TECHNICAL BULLETIN

[Issue No.] FA-A-0123

[Title] Changes in the rating plate of MELSEC-Q series slim type power supply modules

[Relevant Models] Q61SP

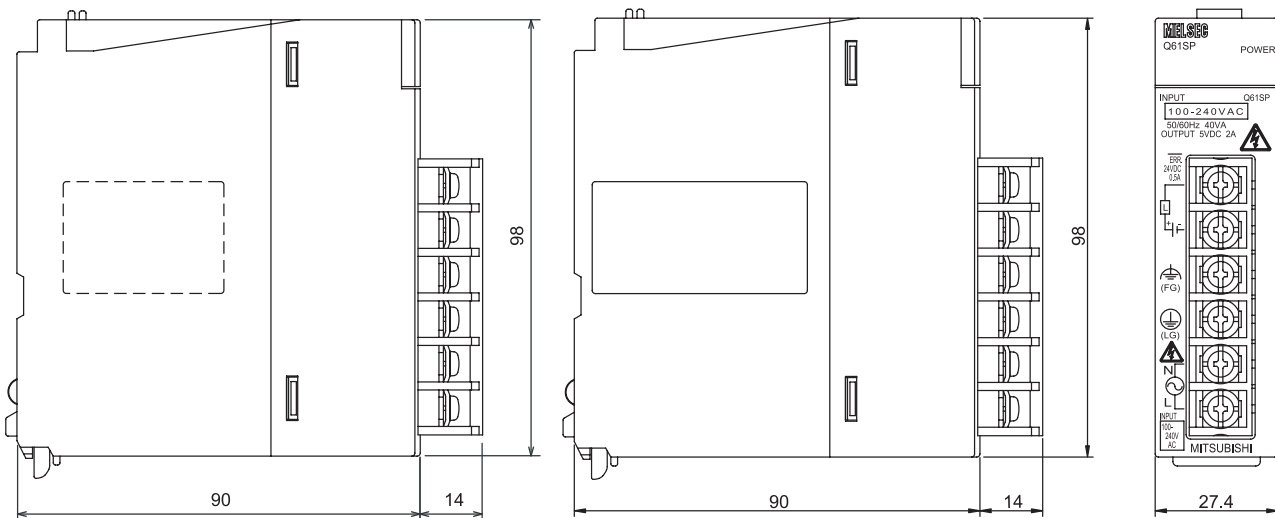
After change, the rating plate will be placed on the left side of the module. (Before change, it is placed on the right side of the module.)

The width of the rating plate will be increased.
